ADDENDUM 01

Roseville Joint Union High School District
West Park High School, Phase 2 – Increment 1
DSA Application Number: 02-118062

DLR Group Project No: 75-19101-00

1 POWER PLAN - FOOTHILL BUILDING - SECOND FLOOR

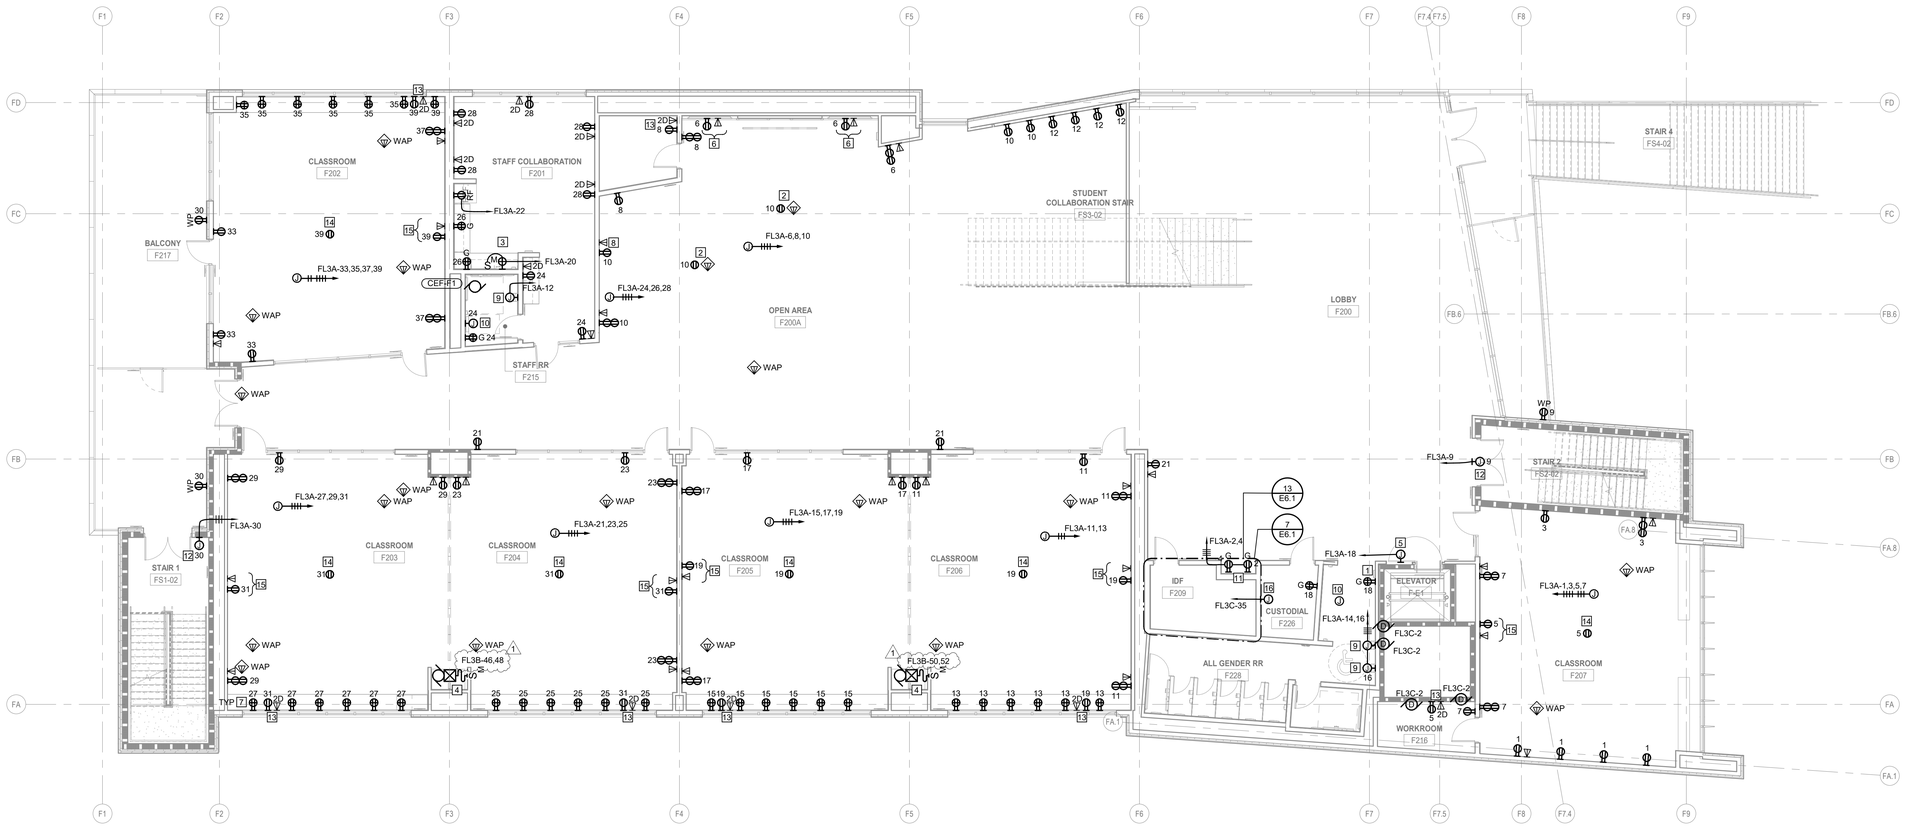
37. SHEET E3.F1.2 – POWER PLAN – FOOTHILL BUILDING – SECOND FLOOR
- *A. UPDATED circuiting for operable partitions*

1 POWER PLAN - FOOTHILL BUILDING - THIRD FLOOR

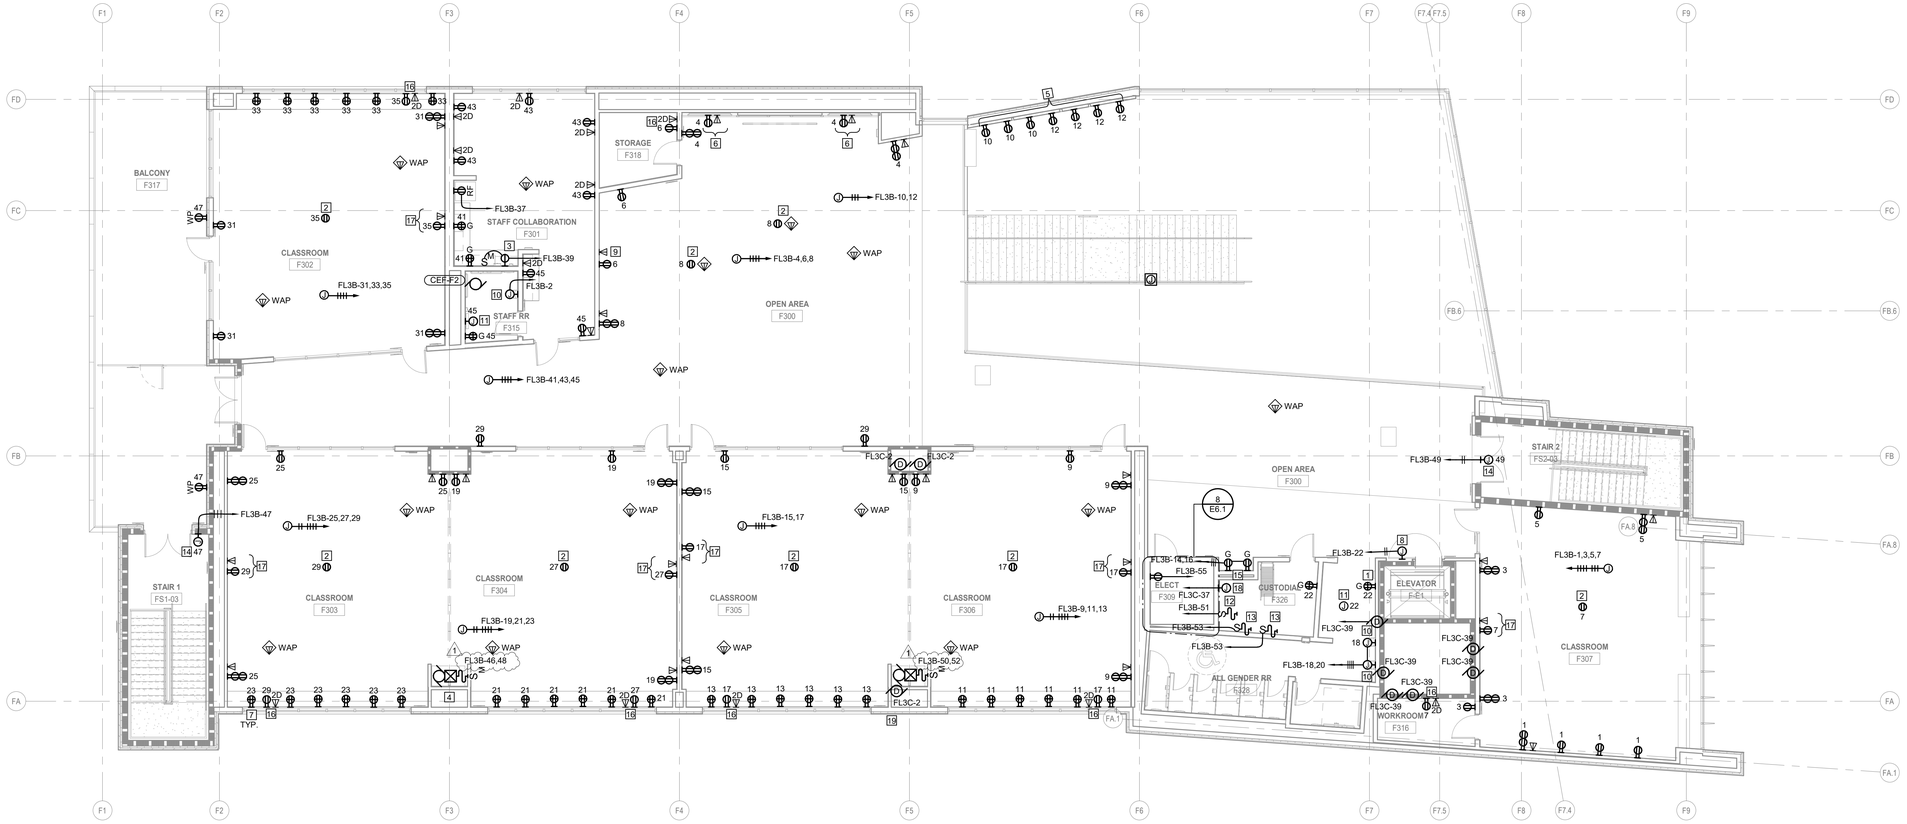
38. SHEET E3.F1.3 – POWER PLAN – FOOTHILL BUILDING – THIRD FLOOR
- *A. UPDATED circuiting for operable partitions*

1 POWER PLAN - SIERRA BUILDING - FIRST FLOOR

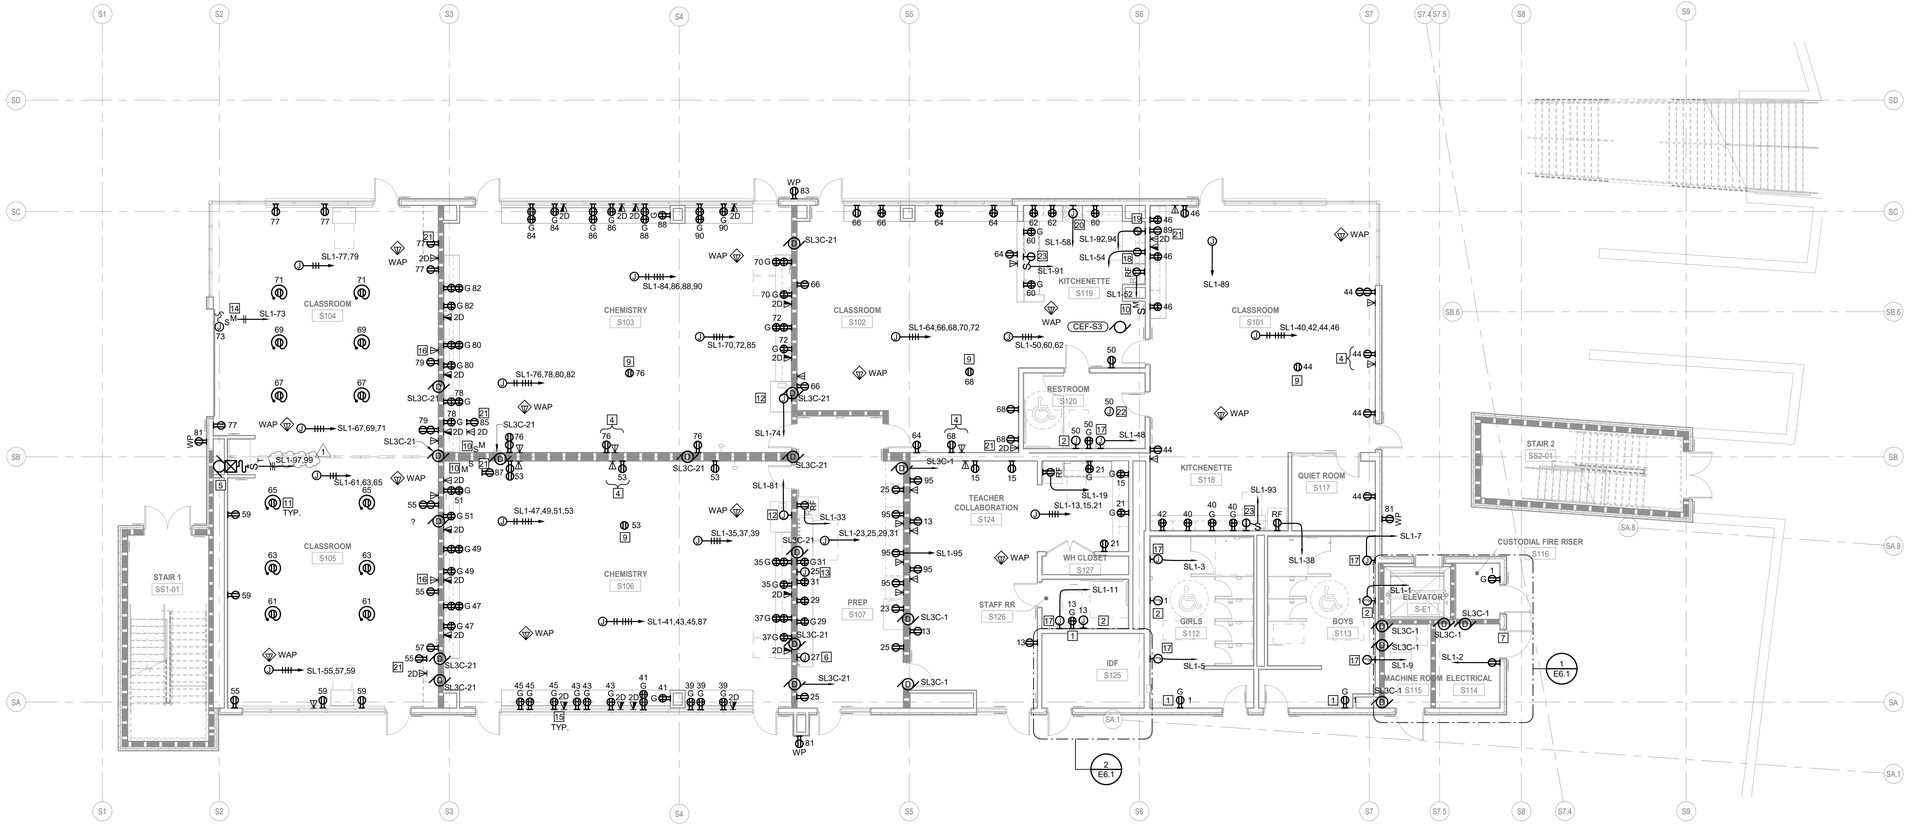
39. SHEET E3.S1.1 – POWER PLAN – SIERRA BUILDING – FIRST FLOOR
- *A. UPDATED circuiting for operable partitions*

1 POWER PLAN - SIERRA BUILDING - SECOND FLOOR

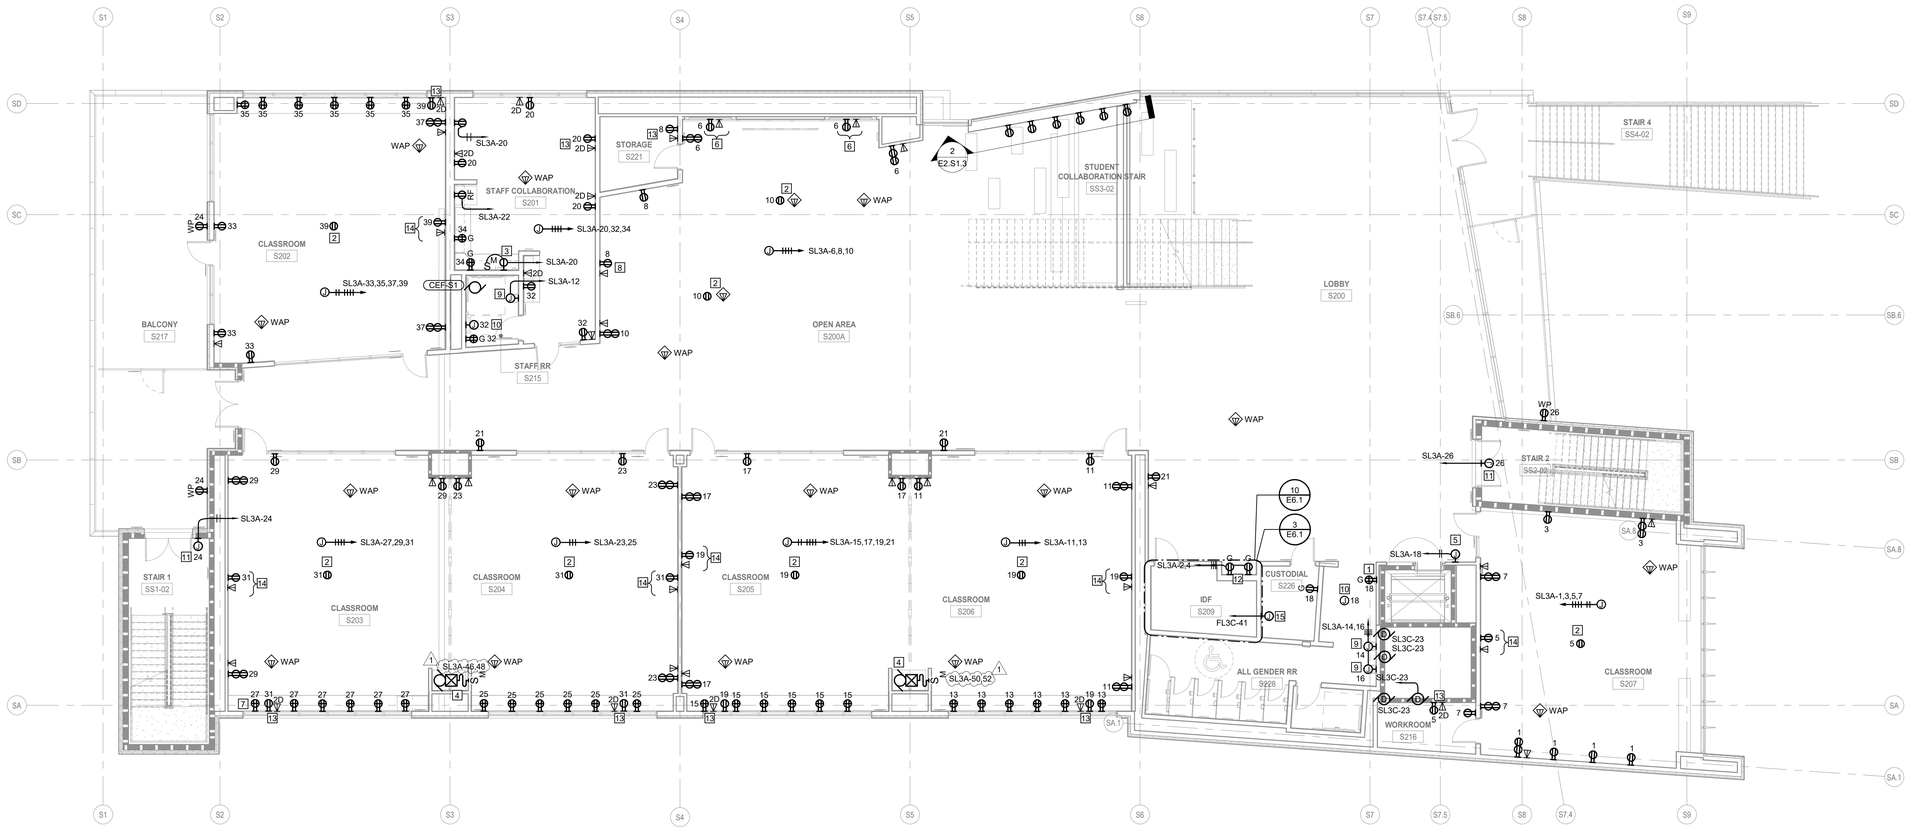
40. SHEET E3.S1.2 – POWER PLAN – SIERRA BUILDING – SECOND FLOOR
- *A. UPDATED circuiting for operable partitions*

1 POWER PLAN - SIERRA BUILDING - THIRD FLOOR

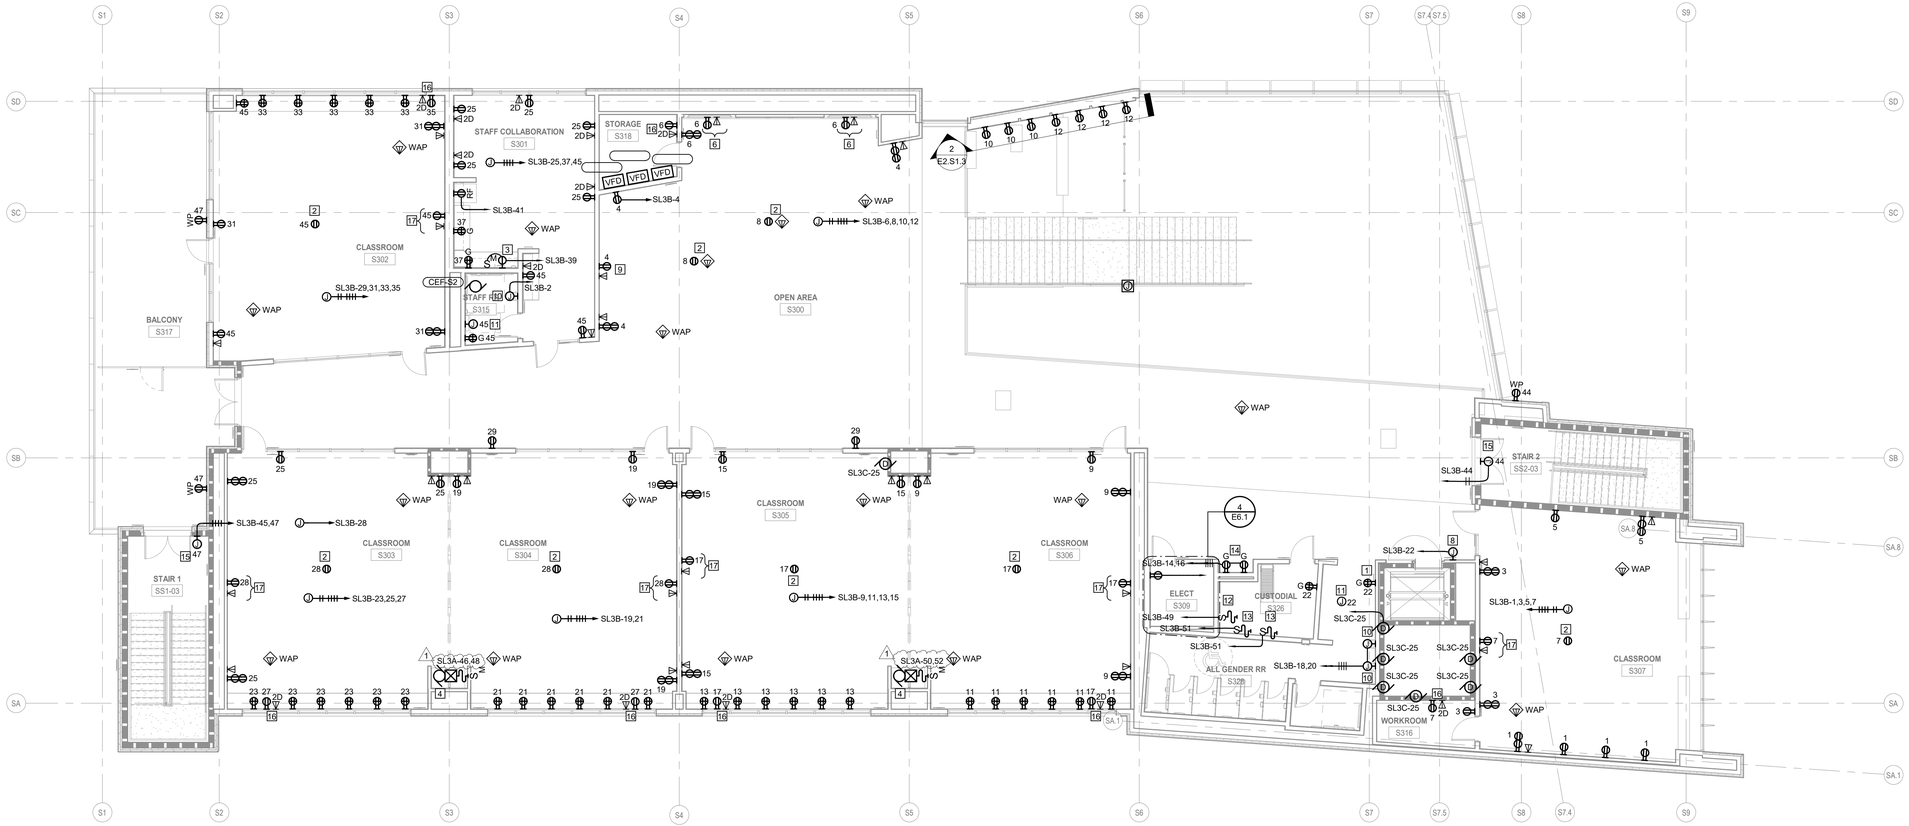
41. SHEET E3.S1.3 – POWER PLAN – SIERRA BUILDING – THIRD FLOOR
- *A. UPDATED circuiting for operable partitions*

1 SIGNAL PLAN - FOOTHILL BUILDING - FIRST FLOOR

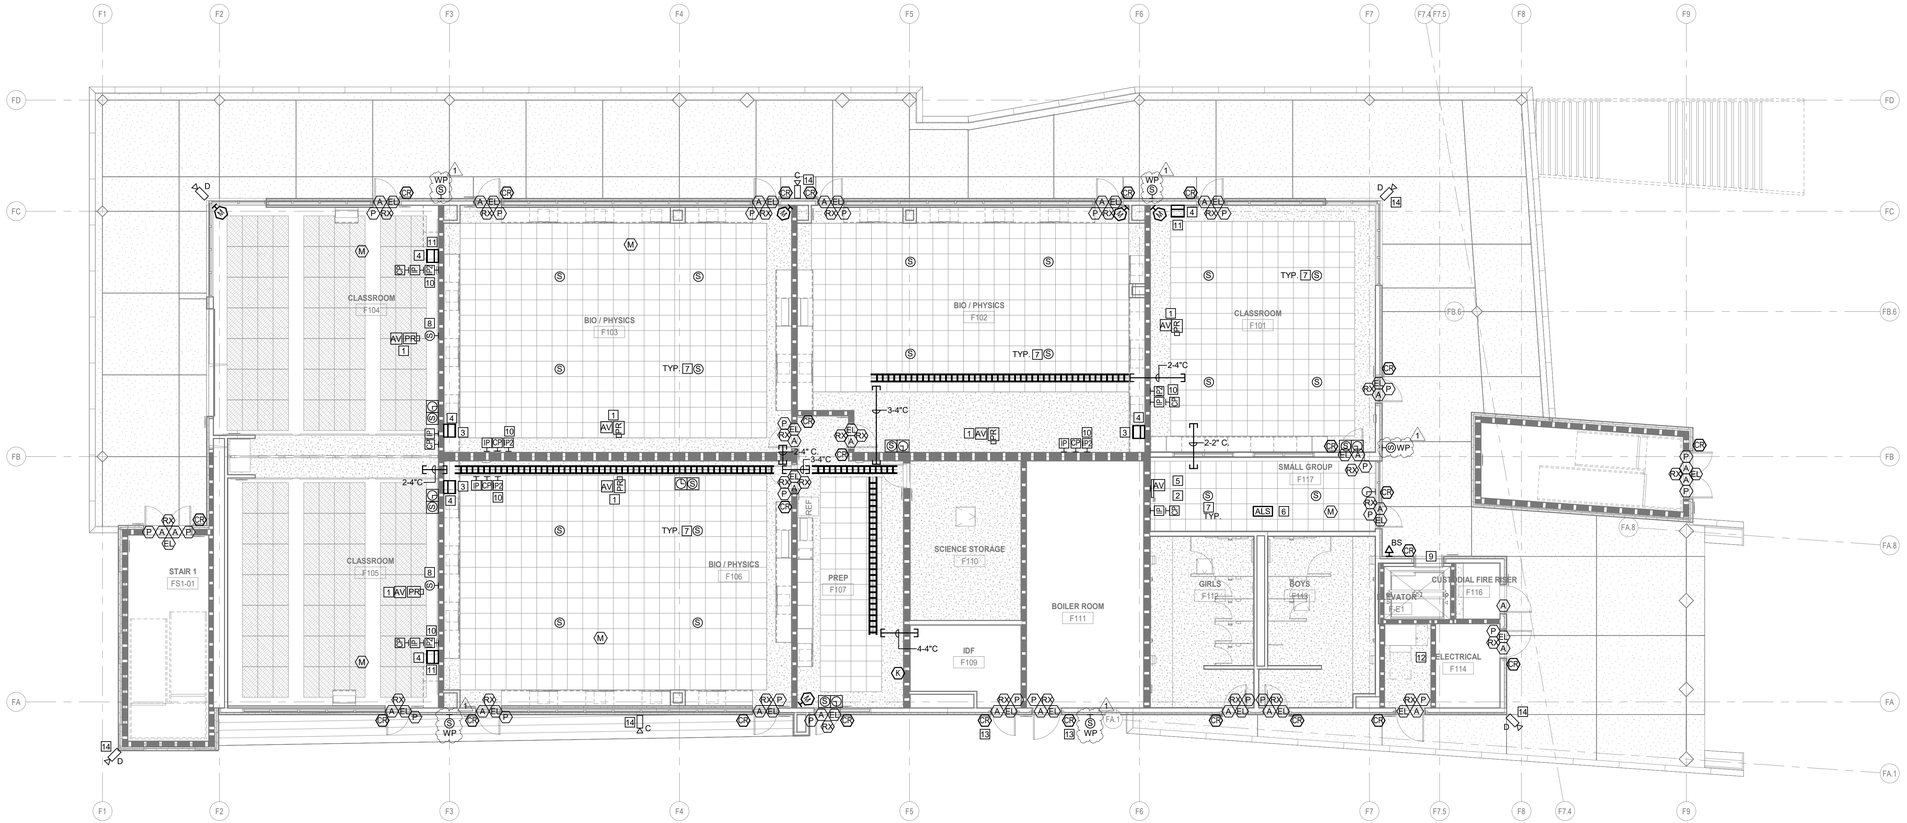
42. SHEET E4.F1.1 - SIGNAL PLAN – FOOTHILL BUILDING – FIRST FLOOR
- *A. ADDED Exterior PA speakers*

1 SIGNAL PLAN - FOOTHILL BUILDING - SECOND FLOOR

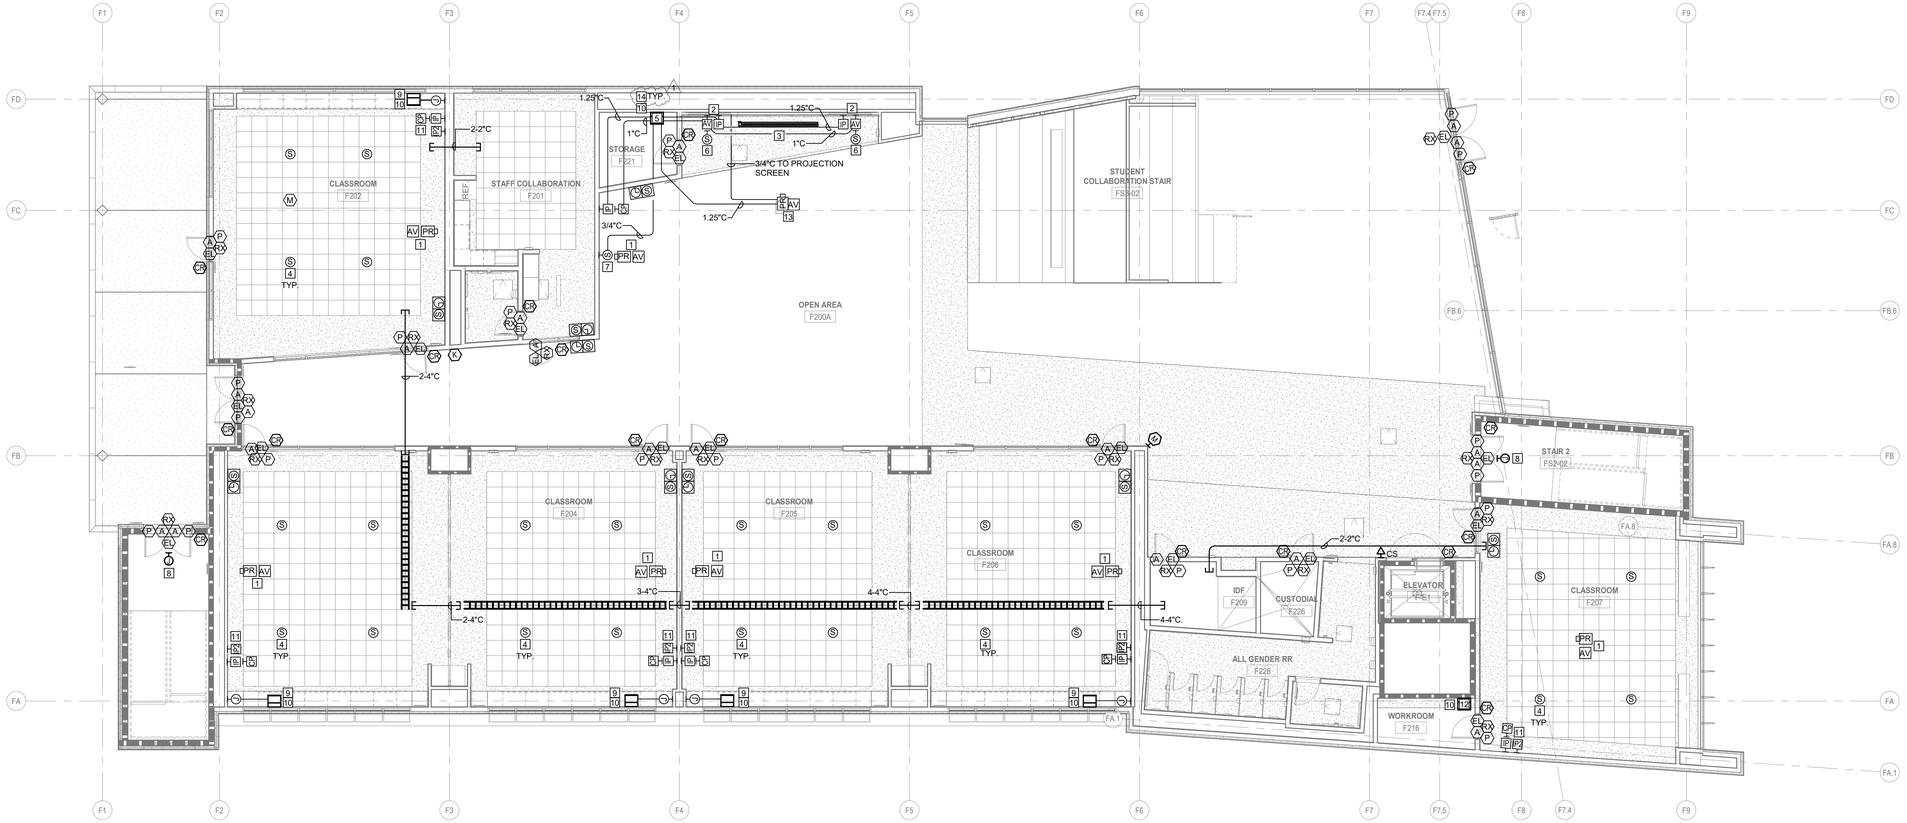
RFI 98 ..... Sheet E4.F1.2 – Keynote 4 indicates the loudspeakers are to be wired to the projector output, while sheet E7.5, detail 1 indicates the audio line is run from the mixer in the equipment rack. Which is correct? (this would apply to all classrooms).

43. SHEET E4.F1.2 - SIGNAL PLAN – FOOTHILL BUILDING – SECOND FLOOR
- *A. ADDED new sheet note for AV.*
